TRANS/WP.29/GRSG/2001/5
22 January 2001

PROPOSAL FOR DRAFT AMENDMENTS TO REGULATION No. 66
(Strength of superstructure)

Transmitted by the Expert from Hungary

Annex 7 - Determination of the position of the centre of gravity of the vehicle.

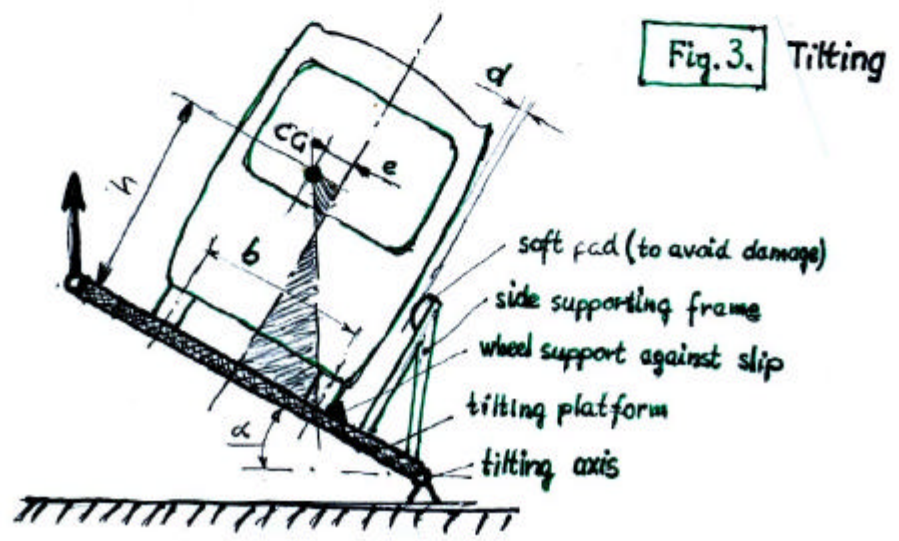
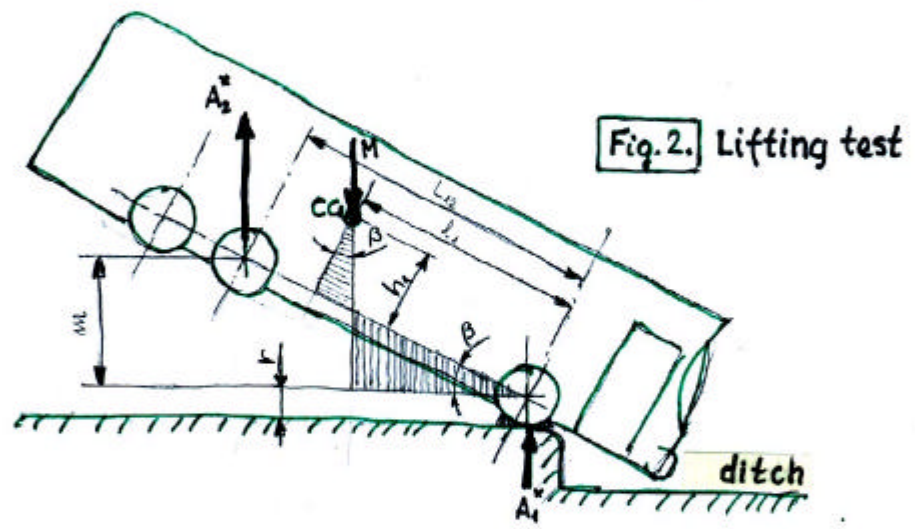
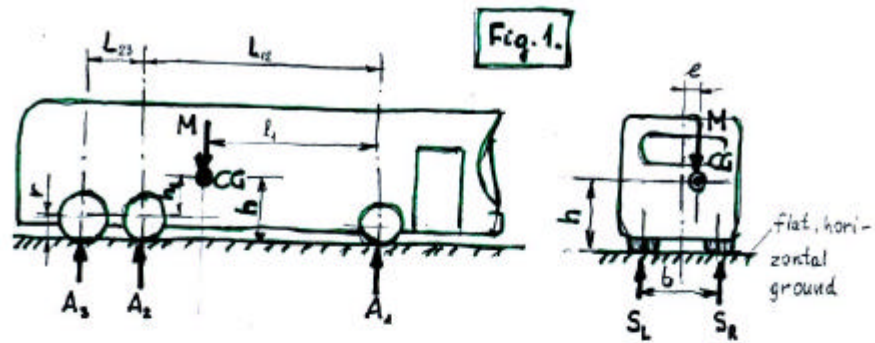
5. Determination of the longitudinal and transverse position of centre of gravity. Using the measured and calculated load parameters, as well as the given geometrical values of the vehicle (see figure 1)

6. Lifting test to determine centre of gravity's height (see figure 2)
- 6.1. Lifting shall be done by both sides, both wheels of the second axle (e.g. by crane) in vertical direction. The spring system of the lifted axle should be sustained and the wheels of the first axle should be chocked.

- 6.2. The lifting height (m) has to result a lifting angle (\mathbf{b}) between 15° - 20° . To ensure this lifting angle either a ditch should be used, or the front axle should be in an elevated position to overcome the limitation of the front angle of approach.

- 6.3. Reaching the required lifting height the vehicle shall be held constantly in this position and the following values have to be measured:
- 6.3.1. exact lifting height (m) measured at the centre of the lifted axle wheels

7. Tilting test to determine the height of the centre of gravity (see figure 3.)
- 7.1. The vehicle shall be placed parallel to the tilting axis on the tilting platform. The wheels should be supported against side

slip. Three side supporting frames with padded heads should be applied to avoid rollover.

- 7.2. The distances between the padded heads and the side wall of the vehicle should be equal and in the range of 60-100 mm when the vehicle stands on the horizontal tilting platform.
- 7.3. All axles of the vehicle should be fixed, the spring system blocked.
- 7.4. The tilting shall be done very slowly, until the unstable position of the vehicle. This position is reached, when:

Fig. 4.

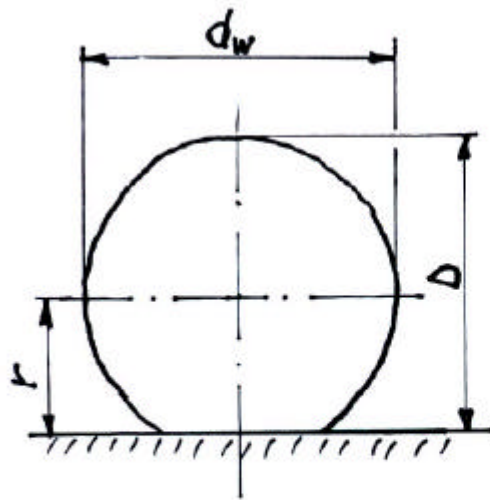
where r is the static rolling radius of the front wheels when they are inflated as specified. The determination of r is shown on figure 4.

$$r = D - \frac{dw}{2}$$
